ACCESSIBILITY ASSESSMENT

July 19, 2021

ADA TITLE II ASSESSMENT

Park Tanglewood
5309 Riverdale Road
Riverdale, Maryland 20737

Map for Barrier ID: AX239809

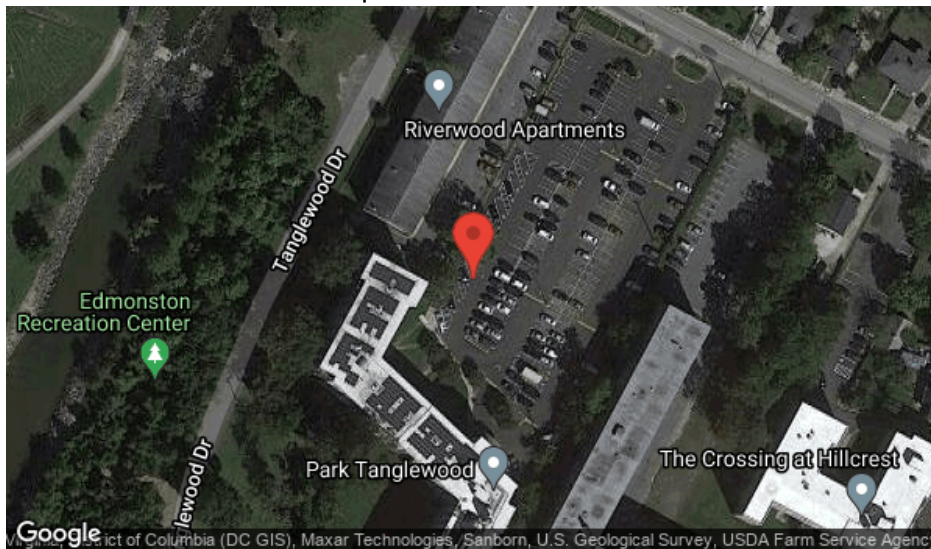
The van access aisle is not on the passenger side of the van, where parking stalls are angled.

The van accessible space closest to the building entrance is an angled space and does not have an access aisle on the passenger side of the space.

Redesign the van stall and aisle in the existing angled parking so that the van aisle is on the passenger side of the van when parked. Width measurements shall be made from the centerline of the markings. [EXCEPTION: Where parking spaces or access aisles are not adjacent to another parking space or access aisle, measurements shall be permitted to include the full width of the line defining the parking space or access aisle.]

Map for Barrier ID: AX239810

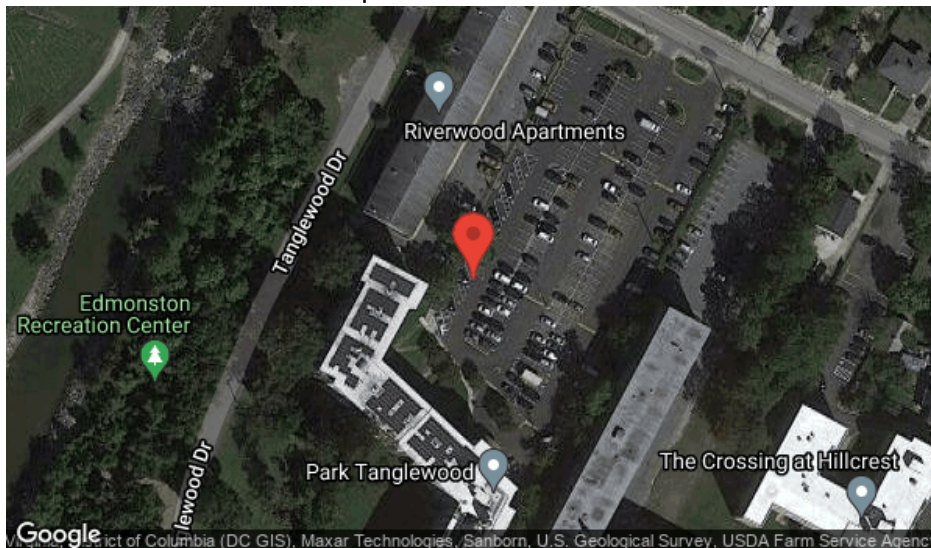
Assembly	Accessible Parking
Type	Parking Space-Van
ADA Standard	UFAS 4.6.3
Barrier Detail	The slope of the parking space is greater than 1:50 (2%).
Location Description	Accessible Parking Space P1-1
Observed	May 18, 2021 by Ouraccessibleworld@gmail.com

The accessible space closest to the building entrance has a cross slope of up to 2.7%.

Remove and replace with a van space that has no more than 1:50 (2%) slope in all directions. Parking spaces and access aisles shall be level with surface slopes not exceeding 1:50 (2%) in all directions. Parking access aisles shall be part of an accessible route to the building or facility entrance. Parked vehicle overhangs shall not reduce the clear width of an accessible circulation route. The quantity and order of magnitude cost estimate provided for this barrier are limited to the extent of the area identified as non-compliant. Additional costs that may be associated with removal of the barrier are not included.

Map for Barrier ID: AX239811

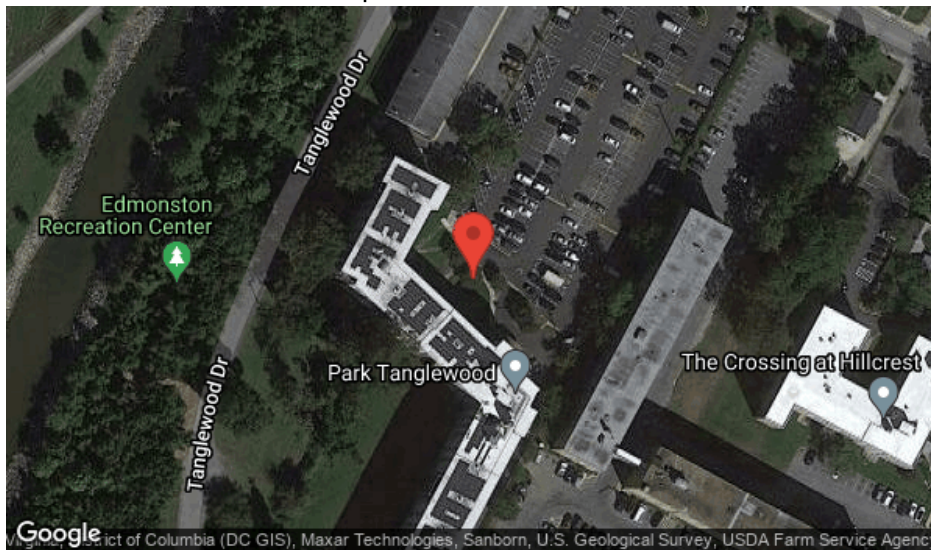
The curb ramp surface has vertical height changes greater than 1/4" that are not ramped.

Site Conditions The curb ramp has a vertical change of up to 3/4".

Reconstruct curb ramp to eliminate surface vertical height changes greater than 1/4". Vertical changes in level of 1/4" high maximum are permitted to be vertical. Vertical changes in level between 1/4" high minimum and 1/2" high maximum shall be beveled with a slope not steeper than 1:2. Vertical changes in level greater than 1/2" shall be ramped.

Map for Barrier ID: AX239831

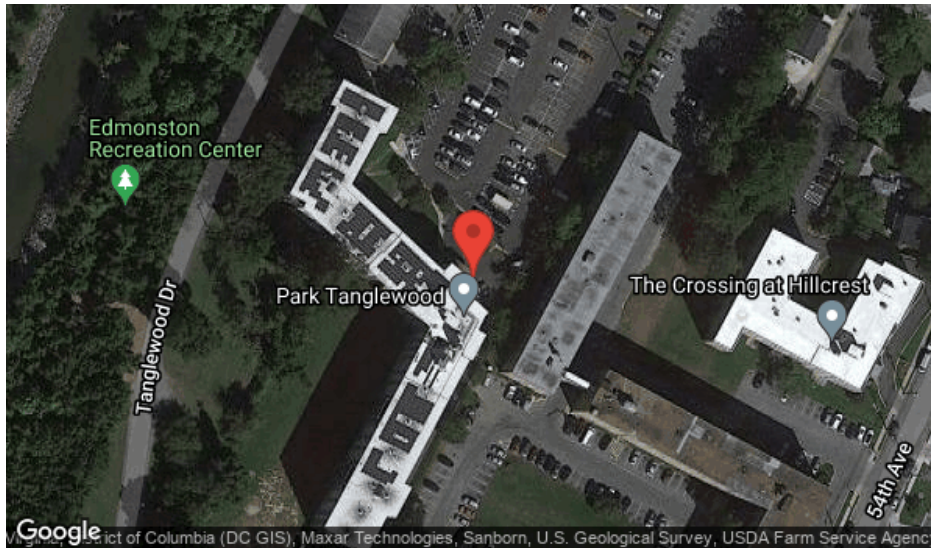
Assembly	Exterior Access Route
Type	Curb Ramp
ADA Standard	406.2
Barrier Detail	A curb ramp is not provided where the accessible route crosses a curb.
Location Description	Entrance
Observed	May 18, 2021 by Ouraccessibleworld@gmail.com
Site Conditions	A curb ramp is not provided at the accessible drop off area.

Install a compliant curb ramp. Compliant curb ramps shall be provided wherever an accessible route crosses a curb. Curb ramp runs shall have a running slope not steeper than 1:12. Cross slope of ramp runs shall not be steeper than 1:48. The running slope in new construction shall be 1:12 maximum. [EXCEPTION: In existing sites, buildings, and facilities built before 1/26/92, ramps shall be permitted to have running slopes steeper than 1:12 where such slopes are necessary due to space limitations. The running slope can be 1:10 to 1:8 (10% to 12.5%) for a maximum rise of 3" OR 1:10 to 1:12 (8.3% to 10%) for a maximum rise of 6".] Where provided, flare slopes shall be maximum 1:10 (10%). Provide a landing at the top of the curb ramp. The landing clear length shall be 36" minimum. The landing clear width shall be minimum 48" wide, and at least as wide as the curb ramp, excluding flared sides. Changes in level are not permitted. Slopes not steeper than 1:48 shall be permitted.

Photos for Barrier ID: AX240451

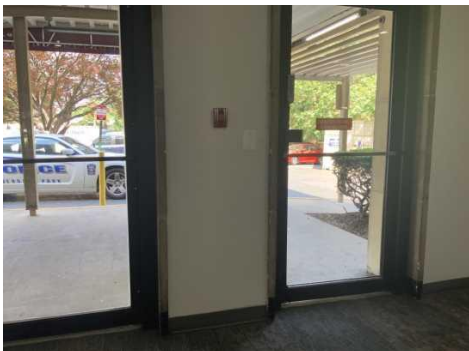
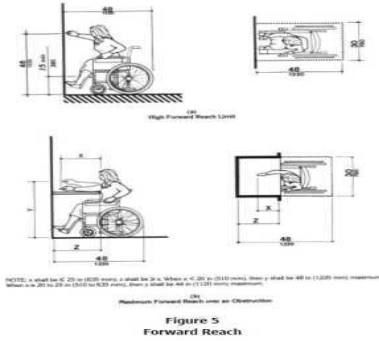
The accessible door with door closer has a sweep period of less than 5 seconds from 90 degrees to a position 12 degrees from latch.

The entry door has a closing speed of up to 1.53 seconds from an open position of 90° to 12 degrees of latch.

Adjust closer or remove and replace closer to ensure that the door has a closure time of at least 5 seconds within 12 degrees of the latch. Door closers and gate closers shall be adjusted so that from an open position of 90 degrees, the time required to move the door to a position of 12 degrees from the latch is 5 seconds minimum.

Map for Barrier ID: AX239807

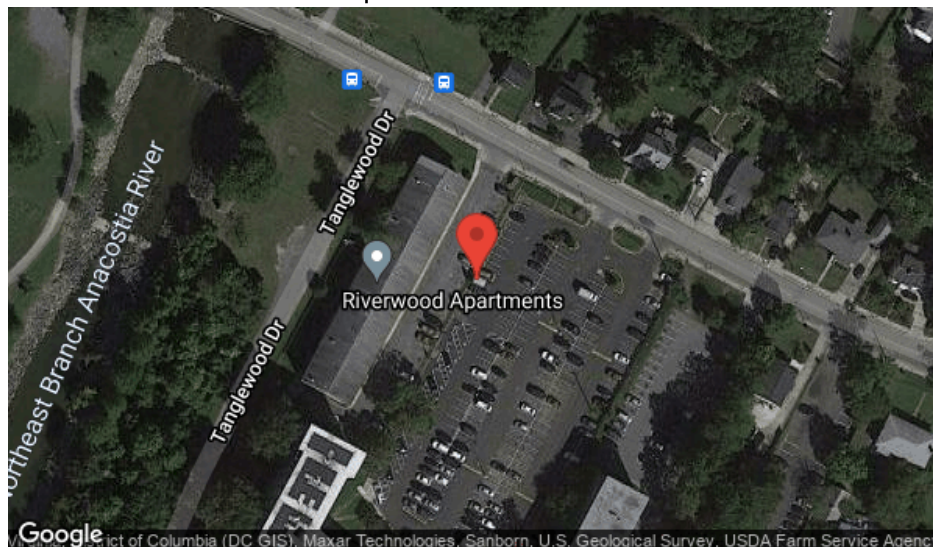
A compliant accessible route is not provided from the property line to the site facilities.

The accessible route does not extend all the way to the street. A route of approximately 128' long by 3' wide is required.

Provide an accessible route from accessible parking spaces, passenger loading zones, public streets, public sidewalks, and public transportation stops. At least one accessible route shall be provided within the site from accessible parking spaces and accessible passenger loading zones; public streets and sidewalks; and public transportation stops to the accessible building or facility entrance they serve. An accessible route has maximum 1:20 (5%) running slope and maximum 1:50 (2%) cross slope. [EXCEPTION: Cross slopes not greater than 1:48 (2.08%) are permitted.] The clear width of walking surfaces shall be 36" minimum. [EXCEPTION: The clear width shall be permitted to be reduced to 32" minimum for a length of 24" maximum provided that reduced width segments are separated by segments that are 48" long minimum and 36" wide minimum.] Where grading to maximum running slope of 1:20 (5% running slope) is not possible, provide a compliant ramped surface within the walkway with maximum slope 1:12 (8.33%) and maximum ramp run rise of 6" without handrails. If a ramped surface with running slopes greater than 1:20 (5%) and maximum 1:12 (8.33%) rises more than 6", handrails are required. A compliant ramp has maximum 1:12 (8.3%) running slope, maximum ramp run rise 30", landings at the top and bottom of ramp runs, handrails where the ramp run rise is greater than 6", and edge protection with exceptions. The cost estimate for this barrier removal is based on grading the running slope to maximum 1:20 (5%). The quantity and order of magnitude cost estimate provided for this barrier are limited to the extent of the area identified as non-compliant. Additional costs that may be associated with removal of the barrier are not included.

Photos for Barrier ID: AX239823

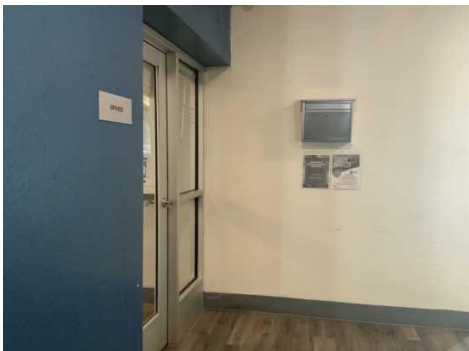
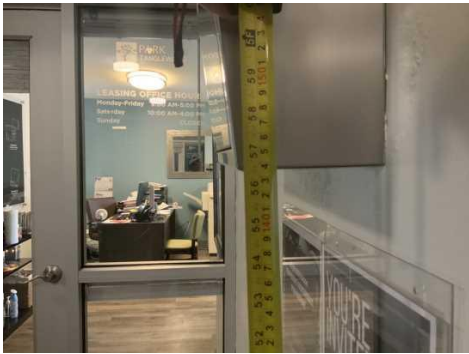
Protruding objects in the 27" to 80" range above finished floor protrude more than 4" into the circulation path along the interior accessible route.

The drop box is mounted 56-1/2" above the floor surface and protrudes 6" from the wall.

Install cane detectors. Objects with leading edges higher than 27" and not more than 80" above the finish floor or ground shall protrude 4" maximum horizontally into the circulation path. [EXCEPTION: Handrails shall be permitted to protrude 4-1/2" maximum.]

Photos for Barrier ID: AX239825

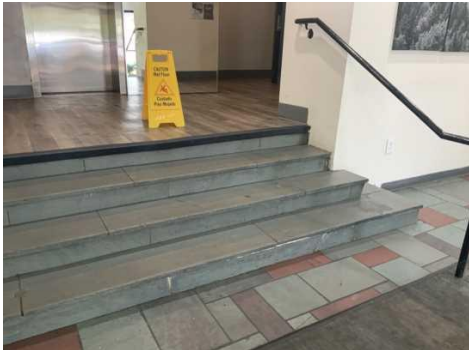
ADVISORY: The stair treads and edge of top landing do not have visual contrast on the leading edge.

Site Conditions A visual contrast strip is not provided on the leading edge of the treads.

ADVISORY: It is advisable, but not required, to install visual contrast on leading edge of each tread, and at the edge of the top landing, so that stair treads are more visible for people with low vision. The estimated cost of installation of visual contrast on each tread is \$87.32 each.

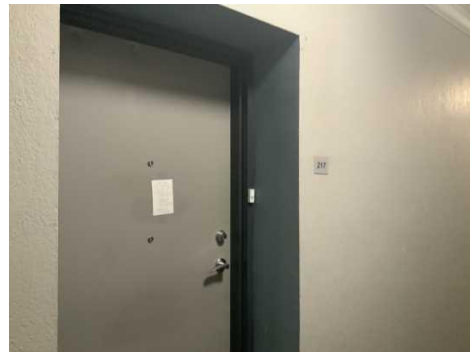
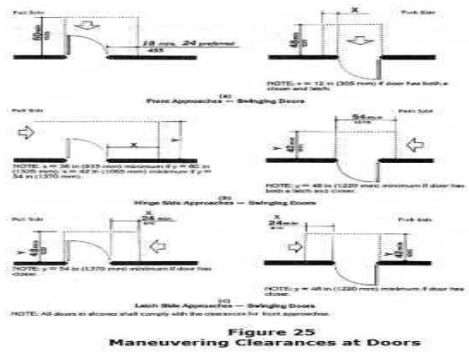
Assembly	Interior Access Route
Type	Door
ADA Standard	UFAS 4.13.6; Fig. 25
Barrier Detail	The accessible door does not have the required maneuvering clearances.
Location Description	Unit 217
Observed	May 17, 2021 by Ouraccessibleworld@gmail.com

Replace with a compliant maneuvering clearance area that is level and clear. Minimum maneuvering clearances at doors that are not automatic or power-assisted shall be as shown in Figure 25. The required depth of the maneuvering clearance is 48" minimum. The required side clearance is 12" minimum on the latch side of the door. Maneuvering clearance shall extend the full width of the doorway and the required latch side clearance. The floor or ground area within the required clearances shall be level and clear. Entry doors to acute care hospital bedrooms for in-patients shall be exempted from the requirement for space at the latch side of the door (see dimension 'x' in Figure 25), if the door is at least 44" wide.

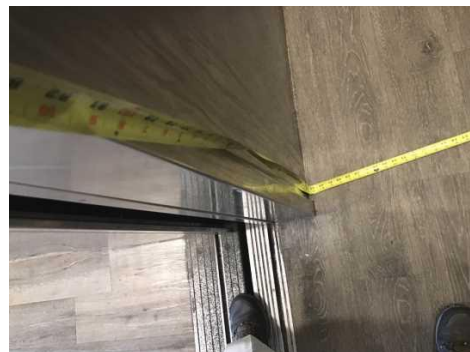
Assembly	Interior Access Route
Type	Elevator
ADA Standard	407.4.1
Barrier Detail	The elevator car dimensions are not compliant.
Location Description	Elevator
Observed	May 18, 2021 by Bryon.scott@bvna.com

Provide an elevator with compliant car dimensions. For a car with a centered elevator door, the minimum allowable door clear width is 42"; the minimum allowable dimension of the inside of the car measured side to side is 80"; the minimum allowable dimension of the inside of the car measured from the back wall to the front return is 51"; the minimum allowable dimension of the inside of the car measured from the back wall to the inside face of the door is 54". For car with a side (off center) elevator door, the minimum allowable door clear width is 36" [EXCEPTION: A tolerance of minus 5/8" is permitted]; the minimum allowable dimension of the inside of the car measured side to side is 68"; the minimum allowable dimension of the inside of the car measured from the back wall to the front return is 51"; the minimum allowable dimension of the inside of the car measured from the back wall to the inside face of the door is 54". For a car with any orientation of elevator door, the minimum allowable door clear width is 36" [EXCEPTION: A tolerance of minus 5/8" is permitted]; the minimum allowable dimension of the inside of the car measured side to side is 54"; the minimum allowable dimension of the inside of the car measured from the back wall to the front return is 80"; the minimum allowable dimension of the inside of the car measured from the back wall to the inside face of the door is 80". For a car with any orientation of elevator door, the minimum allowable door clear width is 36"; the minimum allowable dimension of the inside of the car measured side to side is 60"; the minimum allowable dimension of the inside of the car measured from the back wall to the front return is 60"; the minimum allowable dimension of the inside of the car measured from the back wall to the inside face of the door is 60" [EXCEPTION: Other car configurations that provide a compliant turning space with the door closed shall be permitted]. [EXCEPTION: Existing elevator car configurations that provide a clear floor area of 16 square feet minimum and also provide an inside clear depth 54" minimum and a clear width of 36" minimum shall be permitted.] The quantity and order of magnitude cost estimate provided for this barrier are limited to the extent of the area identified as non-compliant. Additional costs that may be associated with removing and repairing the barrier are not included.
